***MODIFICATION REQUEST:
Sydney University Abercrombie
Precinct Redevelopment
Cnr Codrington Street and Abercrombie
Street
(MP07_0158 MOD 4)***

- Modification to condition D11 Hours of Work

Secretary's Environmental Assessment Report
Section 75W of the *Environmental Planning and
Assessment Act 1979*

Figure 1: Existing Site Layout

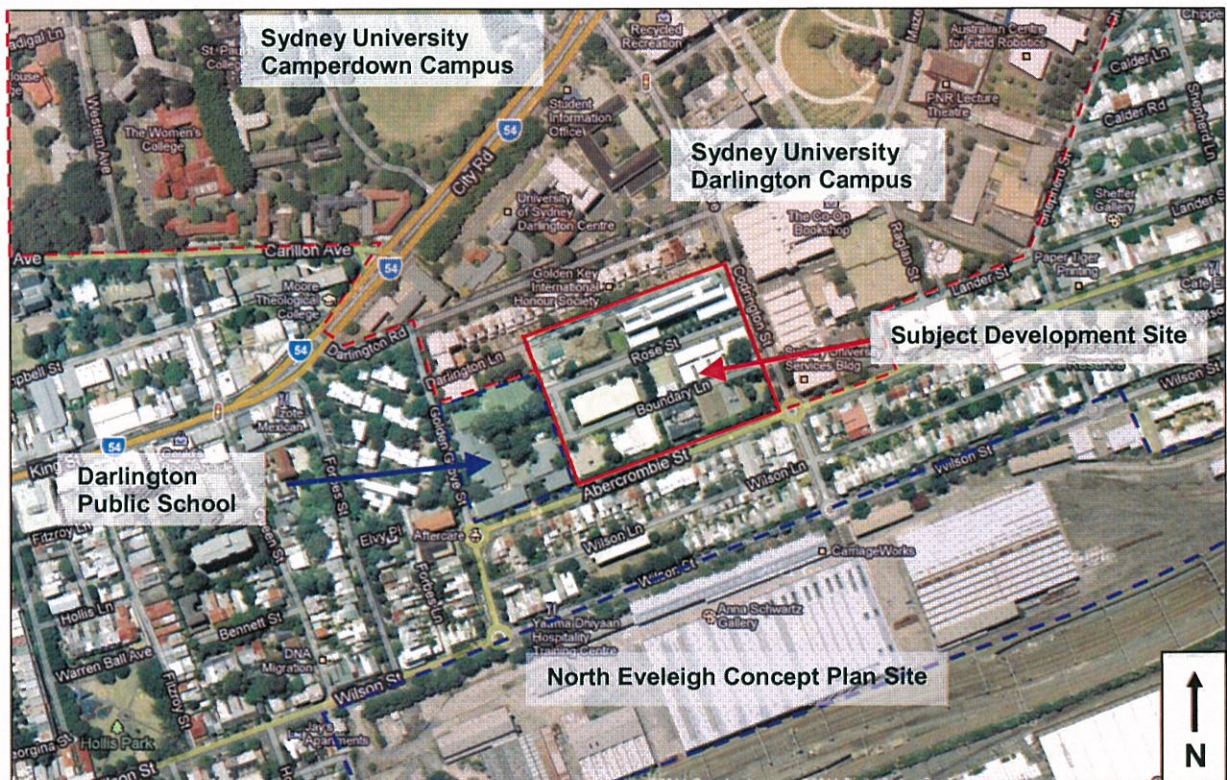
Approximately 63 per cent of the public submissions received were from residents in Abercrombie Street, directly opposite the Abercrombie Precinct Development site. Many of the remaining public submissions were received from residents in nearby Wilson Street and Wilson Lane (see **Figure 1**).
